SERVICE BULLETIN

DATE: 27 OCTOBER 1978

OVERRUNNING CLUTCH ASSEMBLY, PN 369A5350-603 – REWORK INSPECTION OF PN 369A5350-11 CLUTCH SUBASSEMBLY AND PN 369A5361 BALL BEARING PERIODIC INSPECTION OF PN 369A5350-21 CLUTCH SUBASSEMBLY

Figure 1. Overrunning clutch assembly.

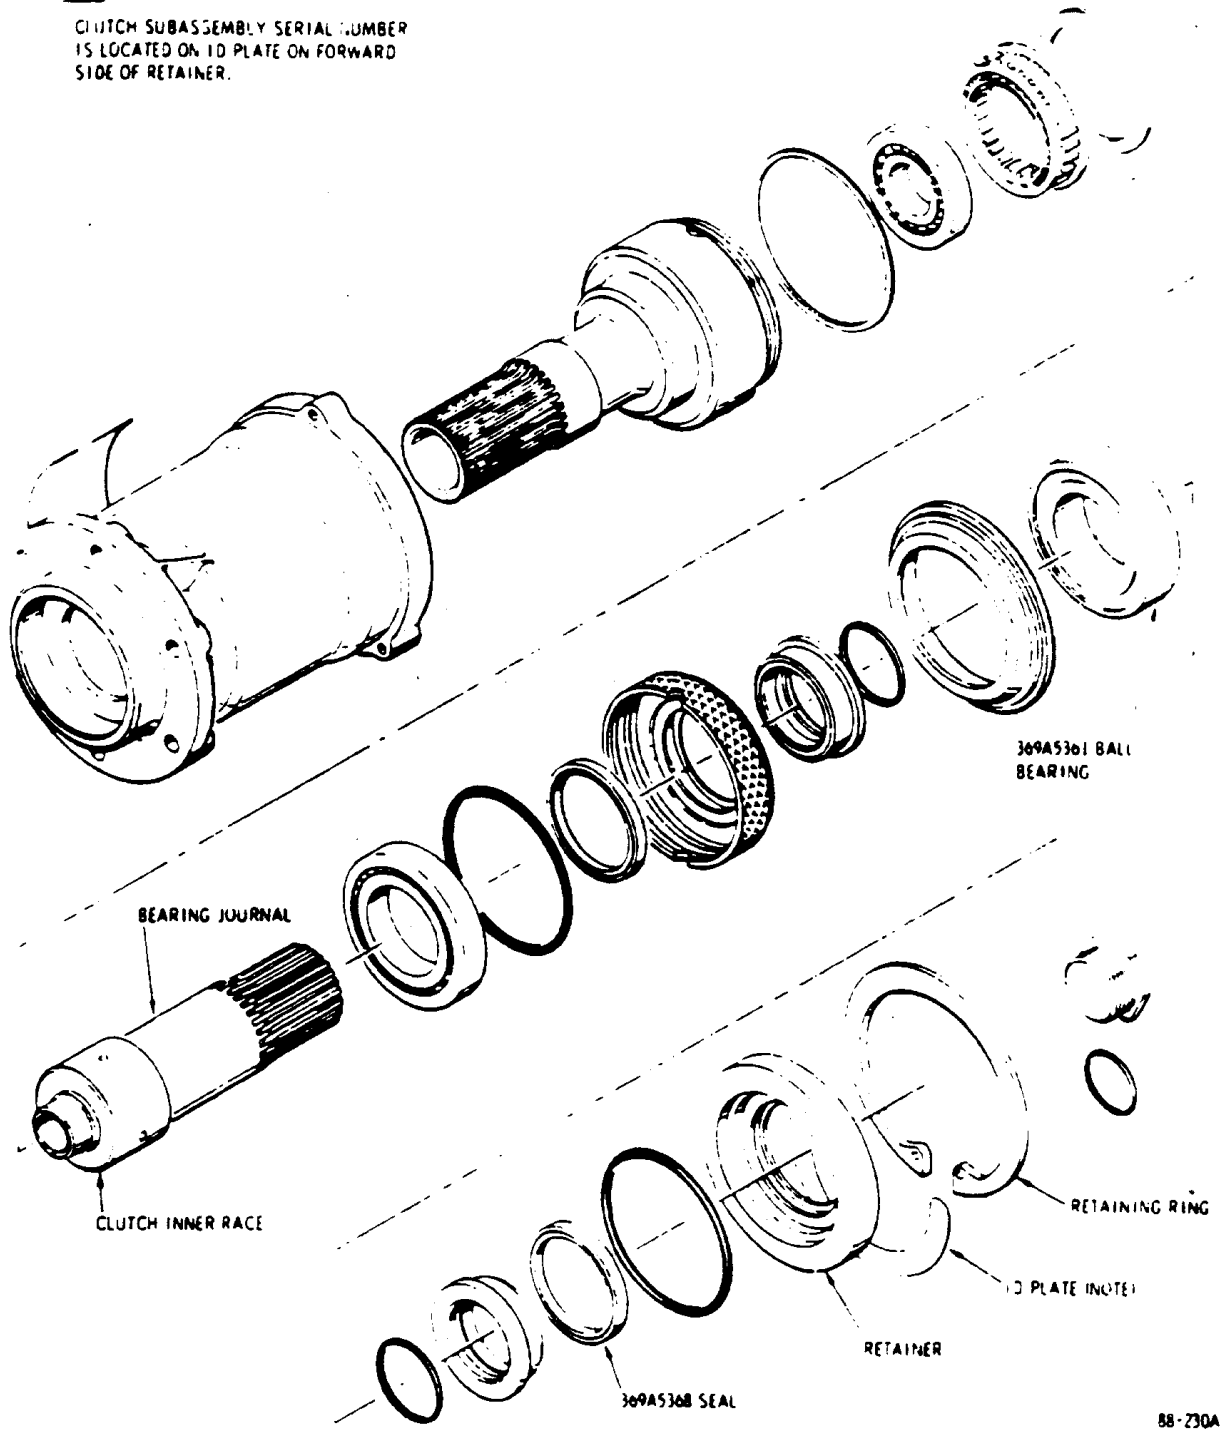
- (7). Remove existing 369A5368 seal and install new 369A5368-3 seal in retainer. Indicate new -3 seal installed by reidentifying 369A5350-11 clutch subassembly to -21 configuration in ID plate on forward side of retainer. (See Note above.)
- (8). Repack bearing 50 percent of capacity with Aeroshell 22 or Mobile 28 grease by packing open side of bearing level without forcing grease through bearing
- (9). Fill void in retainer 75 percent full with grease; reinstall retainer, Flat side ~f retainer faces unit; bevel side is out.

(3). Remove clutch retainer to expose 369A5361 ball bearing (See Figure 1).

CLUTCH SUBASSEMBLY SERIAL NUMBER
IS LOCATED ON ID PLATE ON FORWARD
SIDE OF RETAINER.
